UNITED STATES PATENT AND TRADEMARK OFFICE

APPLICATION NO.	FILING DATE	FIRST NAMED INVENTOR	ATTORNEY DOCKET NO.	CONFIRMATION NO.
10/728,324	12/04/2003	Debendra Mallik	P16831	7342
28062	7590	07/27/2005	EXAMINER	
BUCKLEY, MASCHOFF, TALWALKAR LLC			ANDUJAR, LEONARDO	
5 ELM STREET			ART UNIT	PAPER NUMBER
NEW CANAAN, CT 06840			2826

Office Action Summary	Application No. 10/728,324	Applicant(s) MALLIK ET AL.	
	Examiner Leonardo Andújar	Art Unit 2826

DETAILED ACTION

FIG. 3

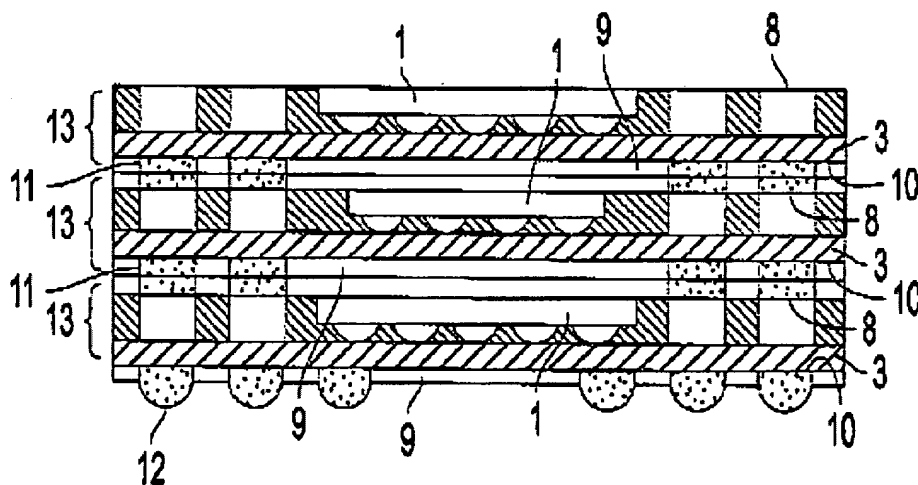
5. Regarding claim 1, Kurita (e.g. figs. 2e and 3) shows an apparatus comprising: an integrated circuit die; an integrated circuit package 3 coupled to the integrated circuit die 1; mold compound 7 in contact with the integrated circuit die and the integrated circuit package; and an interconnect 6 coupled to the integrated circuit package, wherein a first portion (middle portion) of the interconnect is in contact with the mold compound, wherein a second portion (top surface) of the interconnect is not in contact with the mold compound, and wherein a third portion (bottom surface) of the interconnect is in contact with the integrated circuit package.

6. Regarding claim 2, Kurita shows the second portion is an upper portion of the interconnect and the third portion is a lower portion of the interconnect.

7. Regarding claim 3, Kurita shows a second integrated circuit package 3 (second substrate in upward direction); a second interconnect 6 coupled to the second integrated circuit package, wherein the second interconnect is coupled to the first interconnect.

8. Regarding claim 4, Kurita shows a the second integrated circuit package is coupled to the mold compound (e.g. thermally).

9. Regarding claim 5, Kurita shows a second integrated circuit die 1 coupled to the second integrated circuit package; second mold compound 7 in contact with the second integrated circuit die and the second integrated circuit package; and a third interconnect 6 coupled to the second integrated circuit package, wherein a first portion (middle portion) of the third interconnect is in contact with the second mold compound, and wherein a second portion (top surface) of the third interconnect is not in contact with the second mold compound, and wherein a third portion (bottom surface) of the third interconnect is in contact with the second integrated circuit package.

10. Regarding claim 6, Kurita shows a third integrated circuit package 3 (third package in upward direction); a fourth interconnect 6 coupled to the third integrated circuit package, wherein the fourth interconnect is coupled to the third interconnect (electrically).
